## Executive Director's Recommendation

<b>PROJECT</b> <b>Georgetown Canal Plan</b> Chesapeake & Ohio Canal National Historical Park Located between 28 <sup>th</sup> and 36 <sup>th</sup> Streets, NW Washington, DC	<b>NCPC FILE NUMBER</b> 8078
<b>SUBMITTED BY</b> United States Department of the Interior National Park Service	<b>NCPC MAP FILE NUMBER</b> 00:00(00.00)44939
<b>REVIEW AUTHORITY</b> Federal Projects in the District per 40 U.S.C. § 8722(b)(1) and (d)	<b>APPLICANT'S REQUEST</b> approval of comments on concept plans
	<b>PROPOSED ACTION</b> Approve comments as requested
	<b>ACTION ITEM TYPE</b> Staff Presentation

# Georgetown Canal Plan

Approval of Comments on Concept Plans

# The Locks – Option B

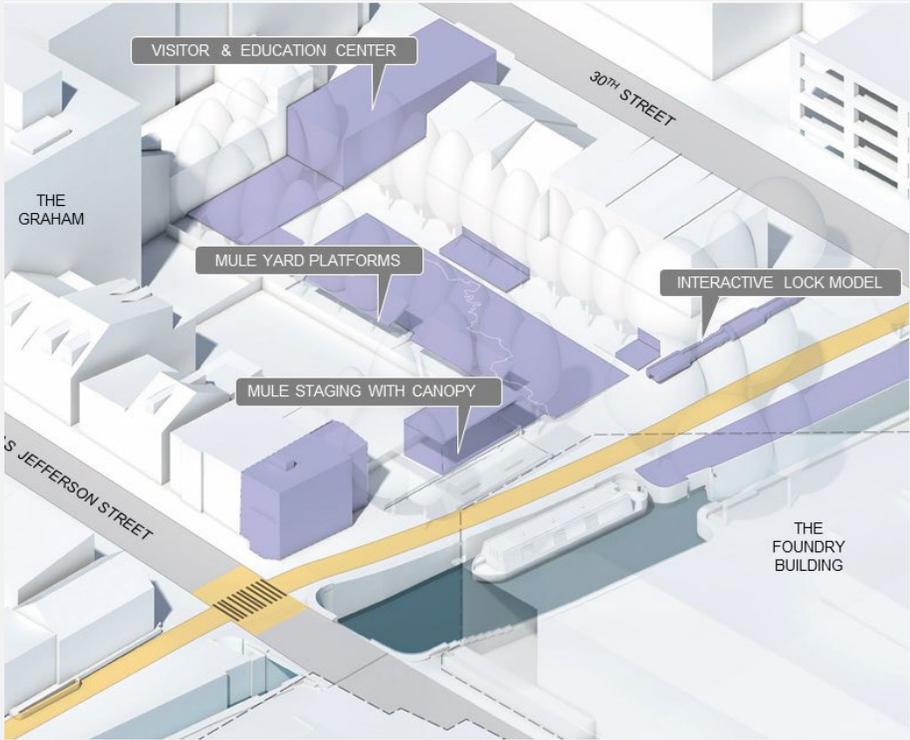
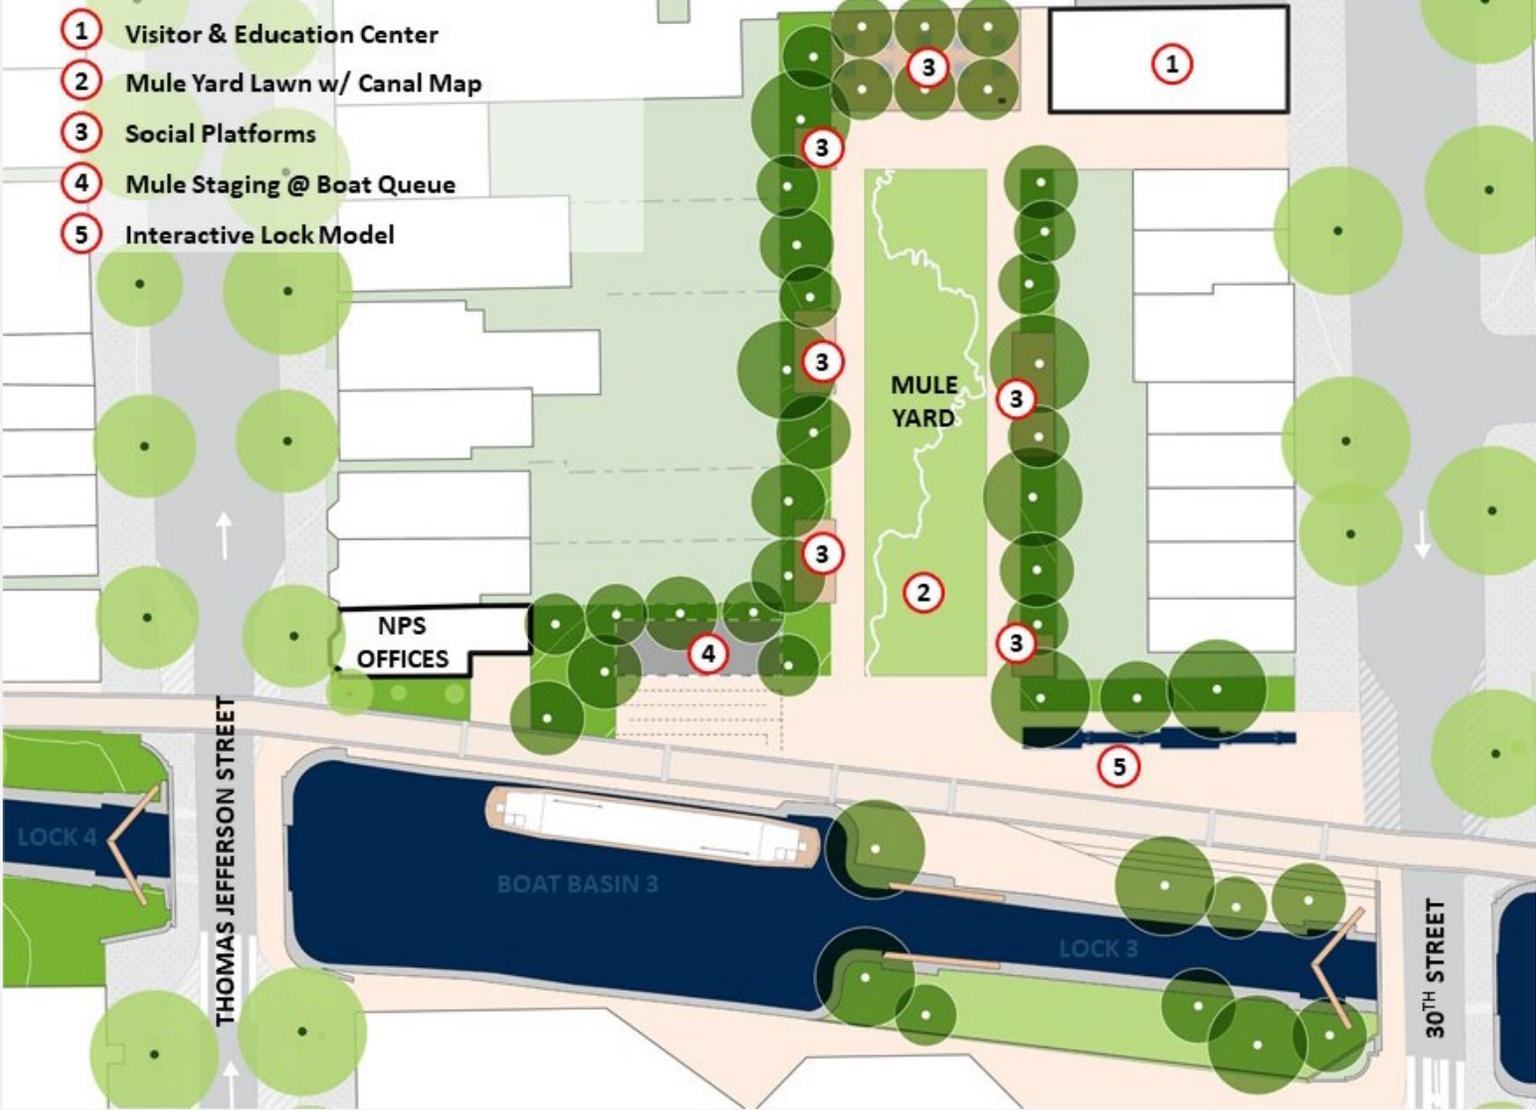
Overall, staff finds that this area can support more significant change, as shown in Option B, to meet NPS Visitor and Education Center space and program needs. NCPC staff supports keeping

# The Market Plazas – Wisconsin Ave Cutout - Option B

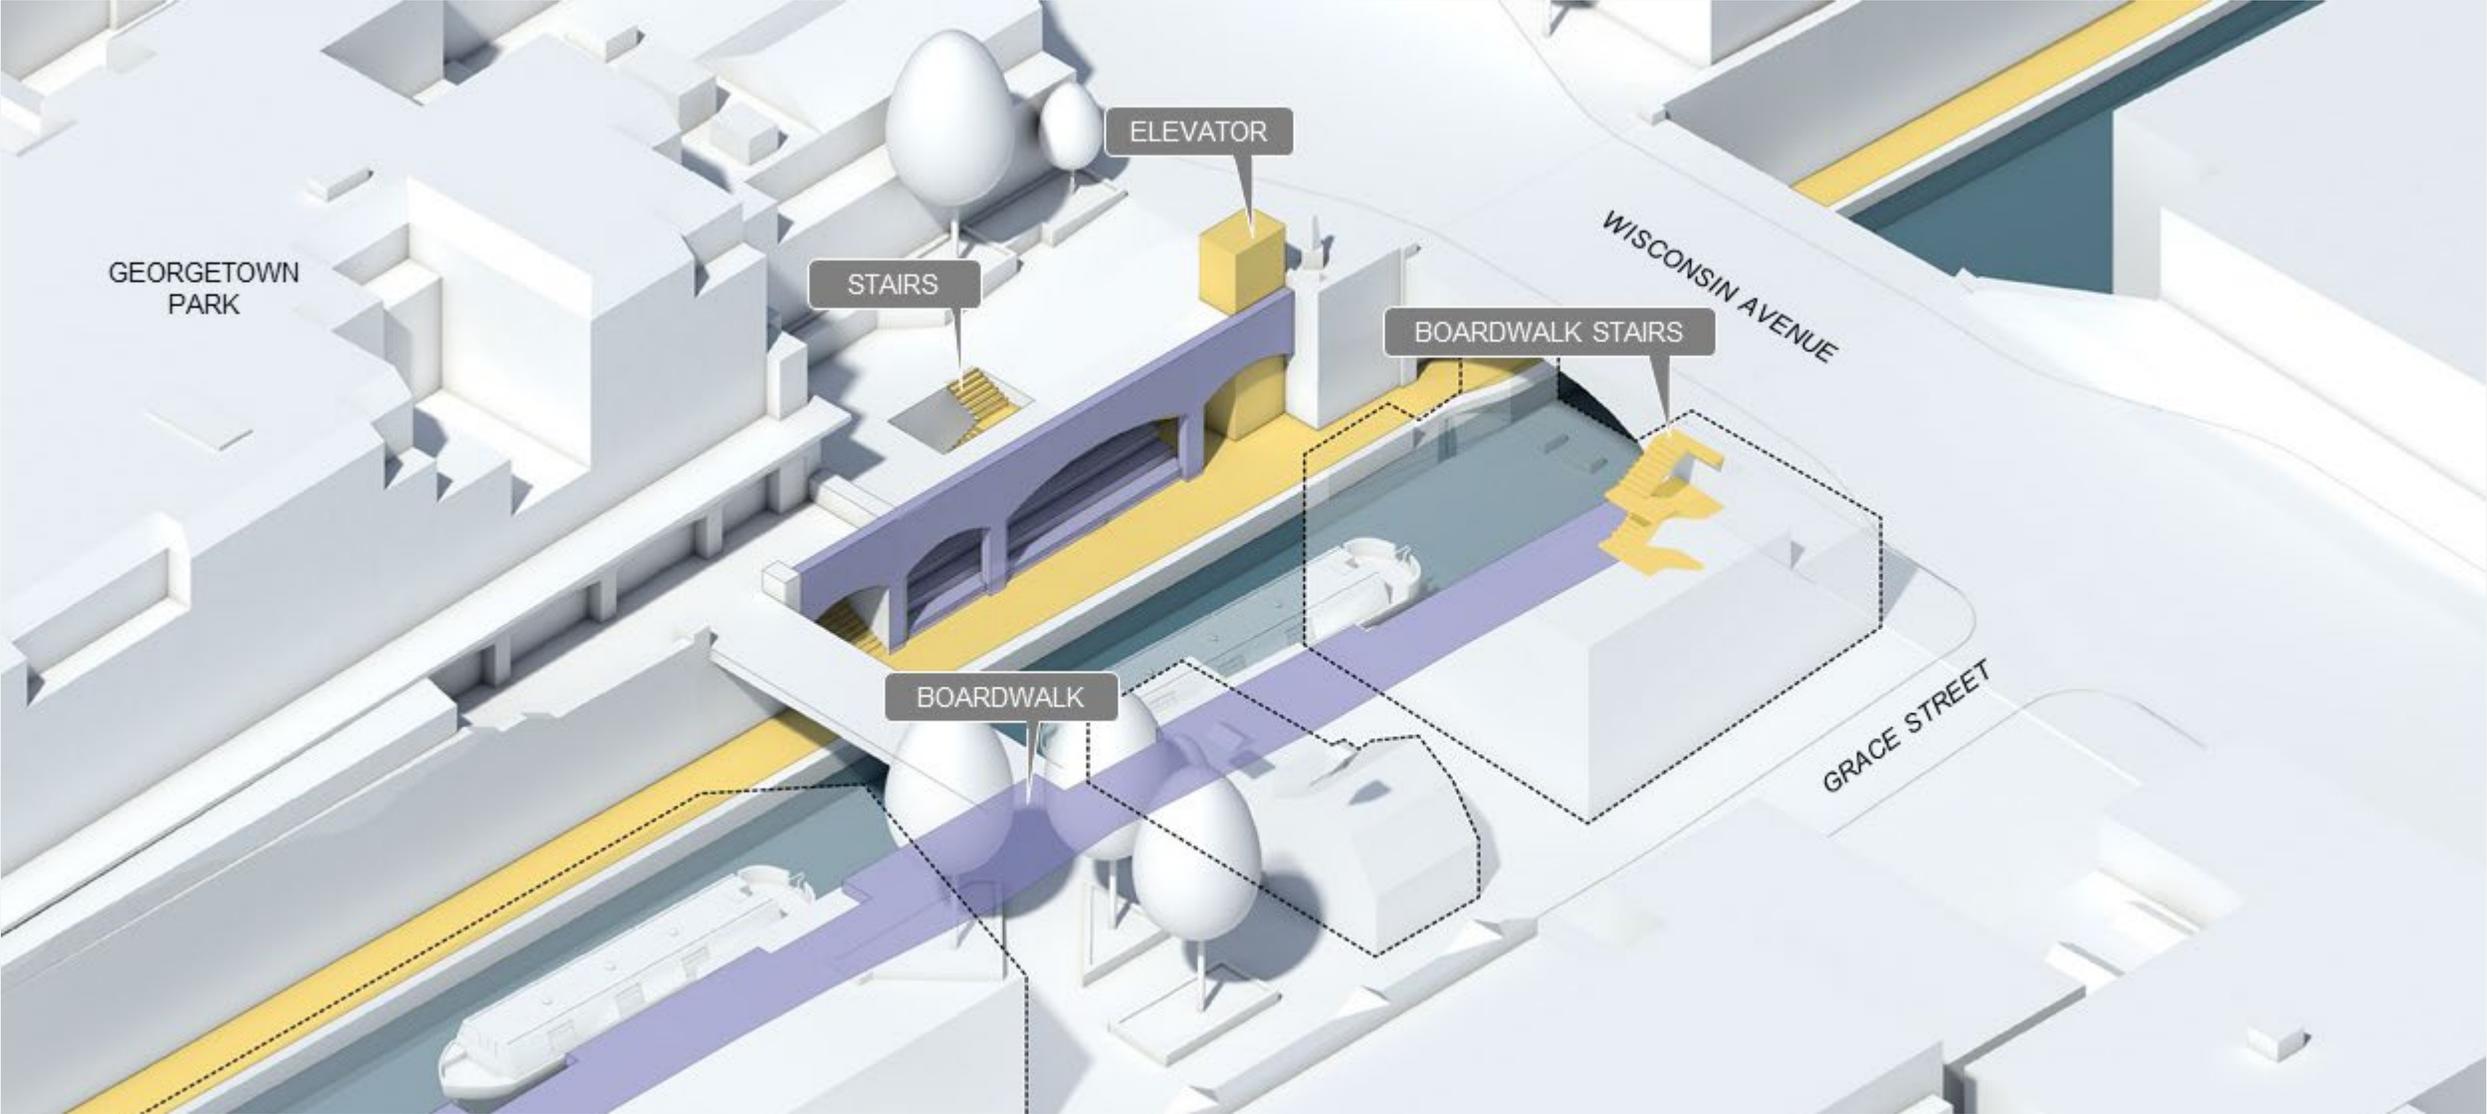
Overall, staff finds that this area can support minimal change, as shown in Option A, and has more potential to impact historic character. Regarding circulation, staff finds that Option B's introduction of boardwalk and boat dock elements on the canal's southern edge within this zone are likely problematic and are only acceptable if they are temporary and removable so that these interventions minimize impacts to the historic character of the canal prism and building and retaining walls. However, these boardwalk interventions must be balanced with changes to the towpath to protect the canal's openness.

Regarding elevators, staff questions Option A's placement of the highly visible elevator adjacent to Wisconsin Avenue, which also relocates the Commemorative Obelisk which as historic integrity of location. Staff prefers the more recessed elevator location in Option B but encourages the applicant to explore other elevator placement solutions. Staff generally encourages locating the proposed elevators in less visually prominent locations, incorporating elevators in a manner compatible with historic features, or screening elevators behind vegetation. Staff recommends the applicant consider security implications, maintenance requirements, and visual impacts of the proposed elevators.

# The Market Plazas – Option A

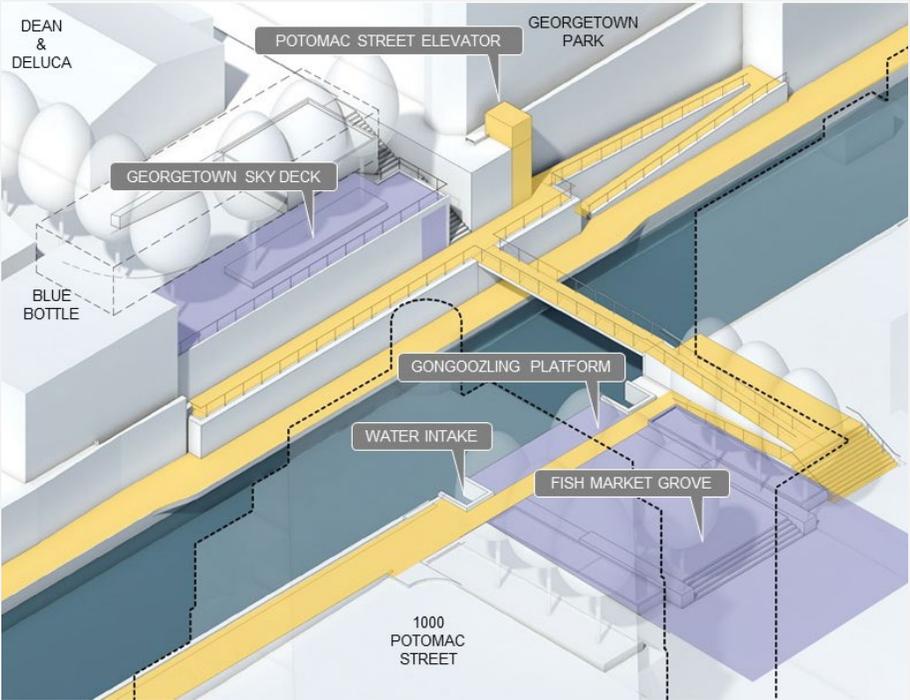
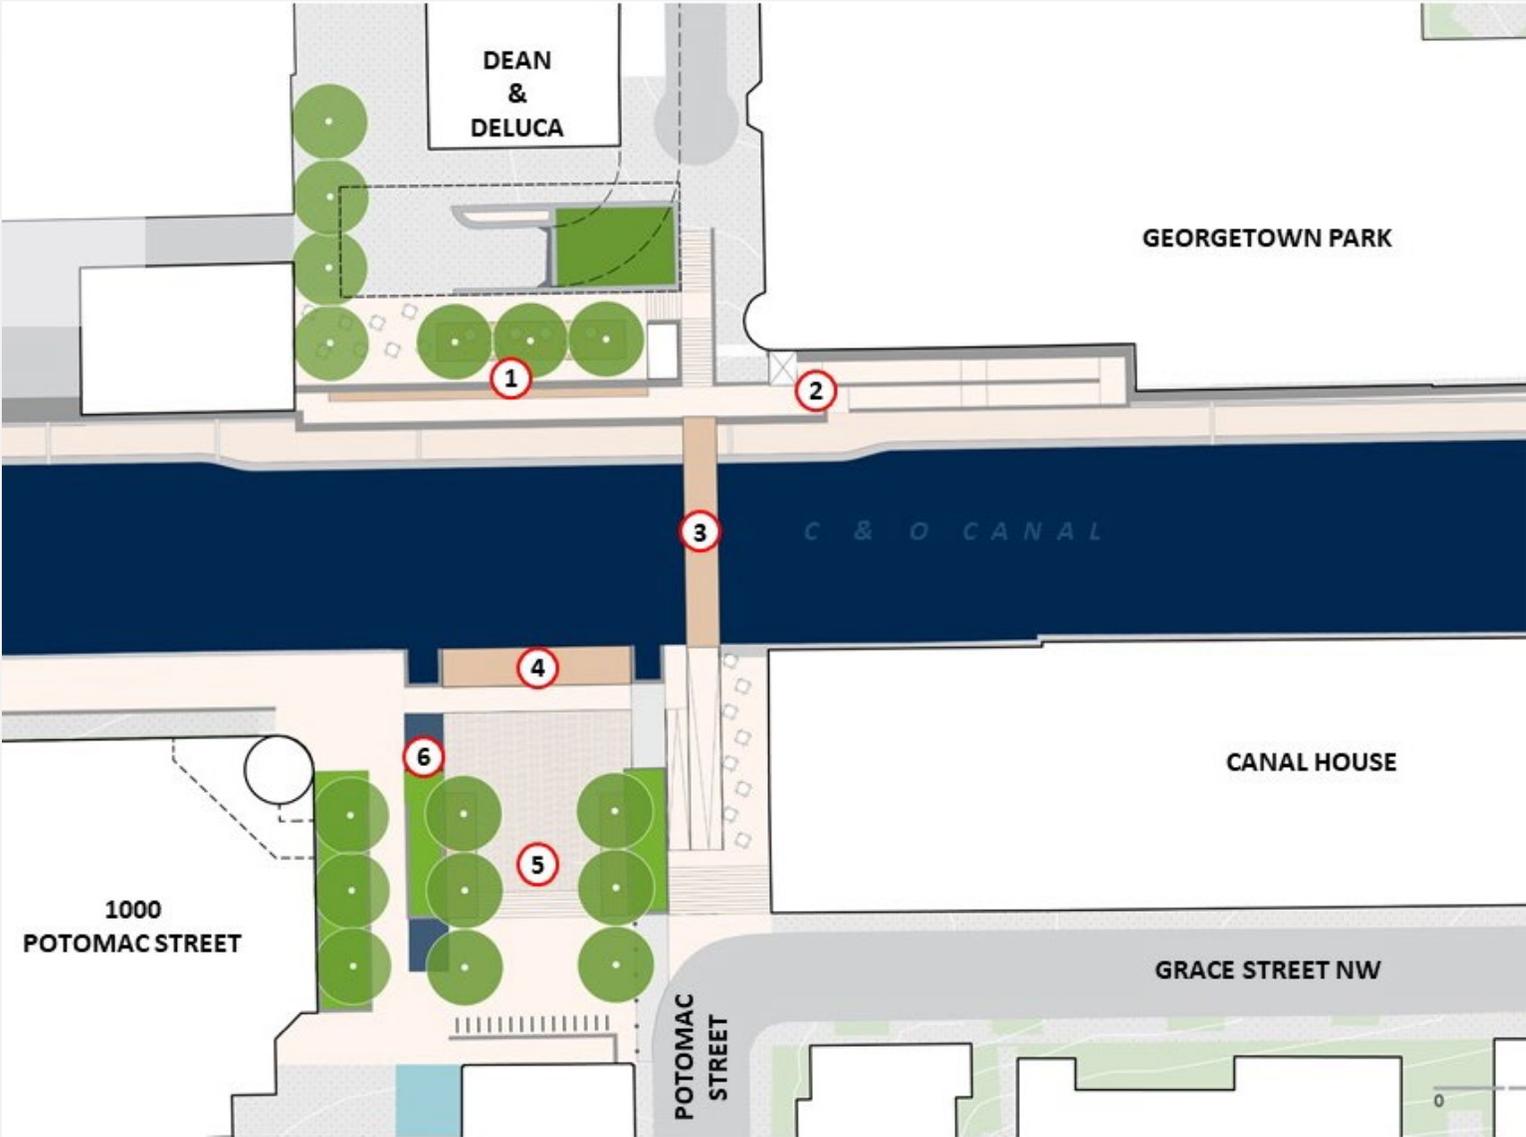
Option A protects the historic character and the spatial composition of the north wall framing the canal, provides a shaded elevated viewing and sitting area, and maintains more level plaza area for outdoor programming and events. However, it does not provide a strong north-south visual and spatial connection between the north and south plazas.

# The Market Plazas – Option B

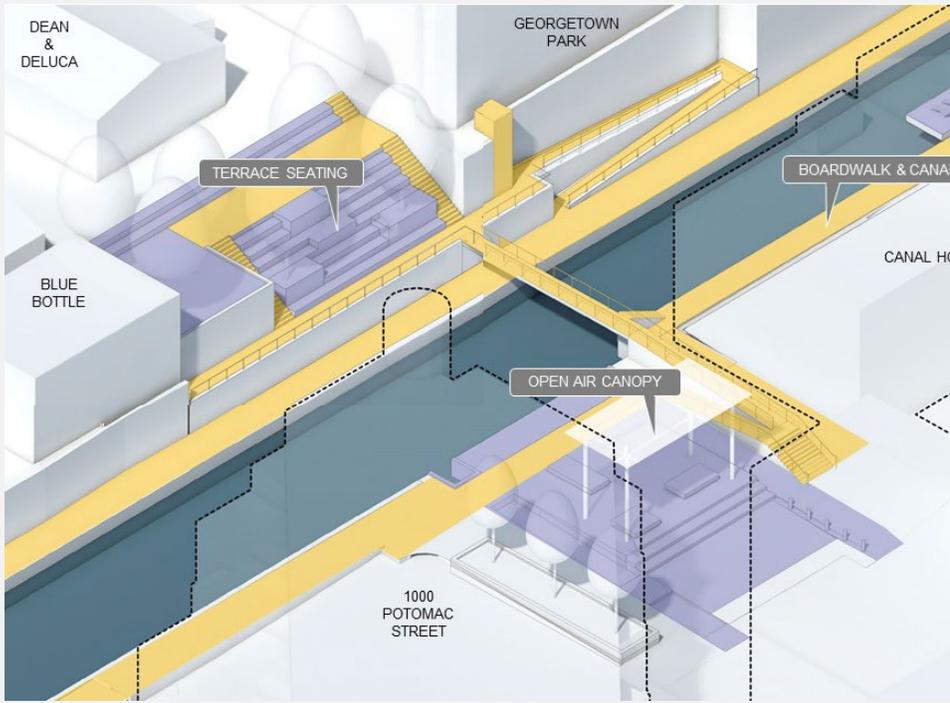
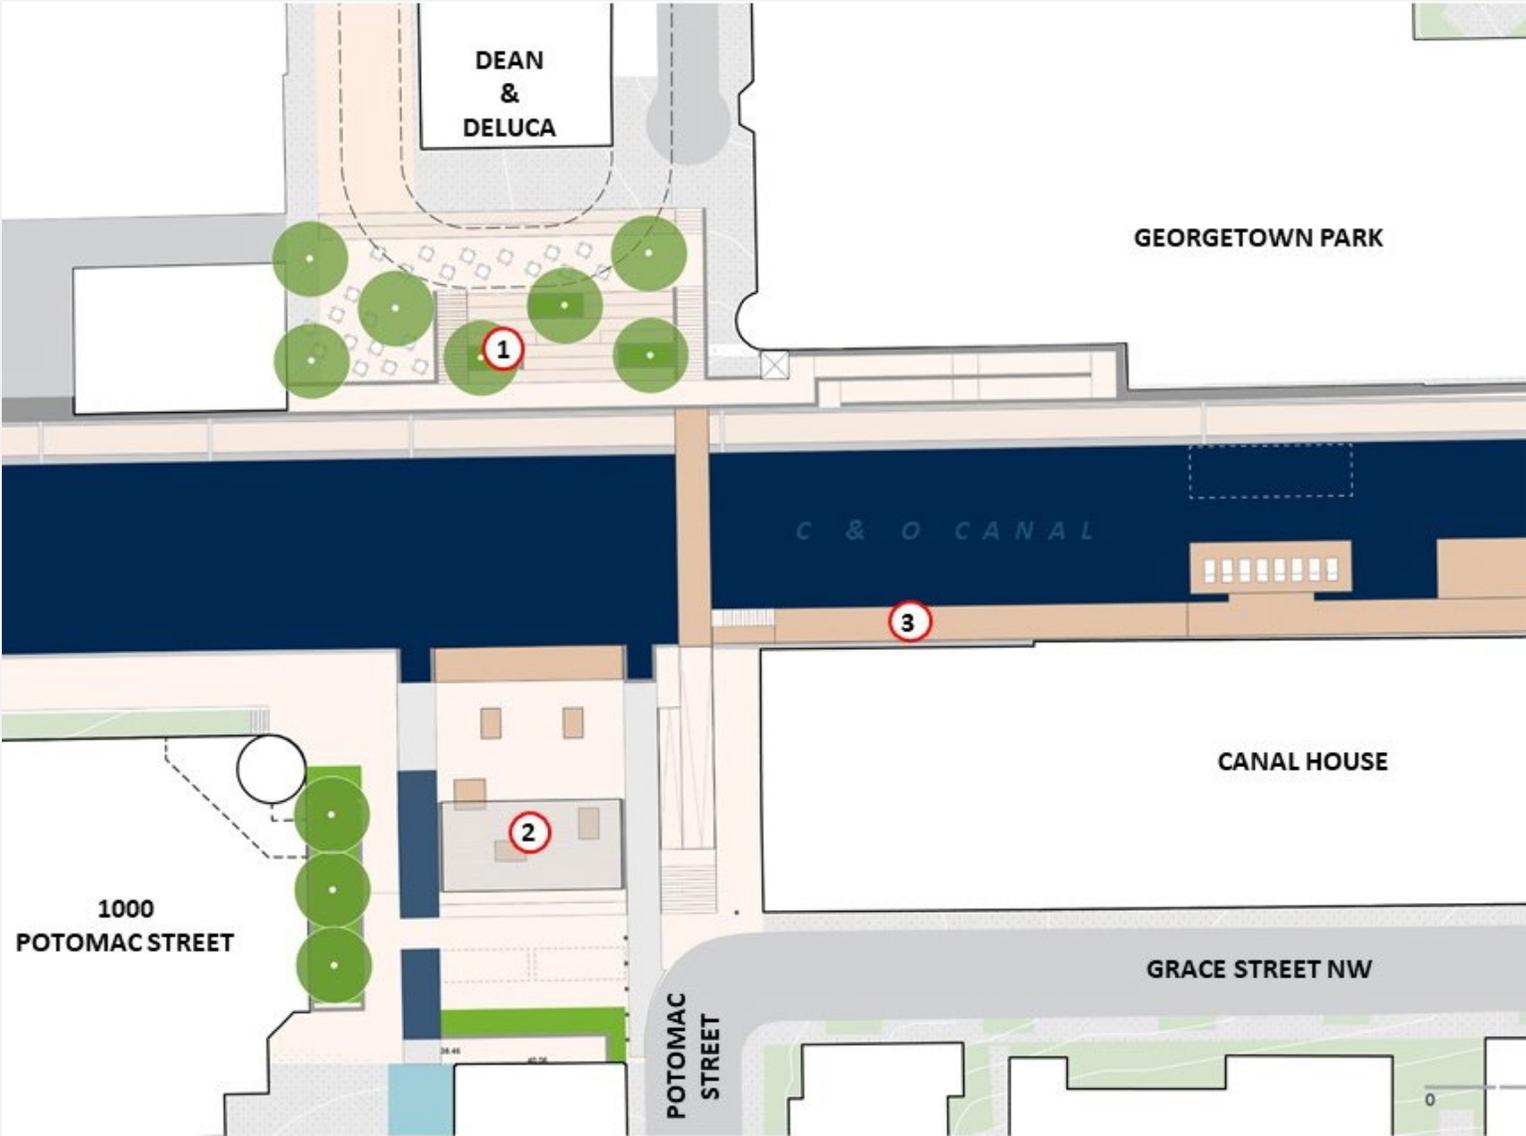
- Option B provides a north-south visual and spatial connection between the two plazas as well as additional seating space for pedestrians. However, it has more potential to impact historic character, particularly the north retaining wall framing the canal. Option B also impacts circulation and service routes on Potomac Street NW which provides access to adjacent buildings and businesses.

- **Finds** that the proposed Fish Market Canopy at Fish Market Square overwhelms the intimate space that exists today.
- **Recommends** the use of temporary canopy structures when needed.

- **Requests** additional documentation on the following to help determine a preferred approach:
  - The feasibility of constructing Option B's terraced seating steps and related improvements (access reconfigurations for the Georgetown Market House and surrounding buildings and regrading along Potomac Street NW).

- How visitors will use and experience Options A and B.
  - Visualizations of the proposed designs for Options A and B.
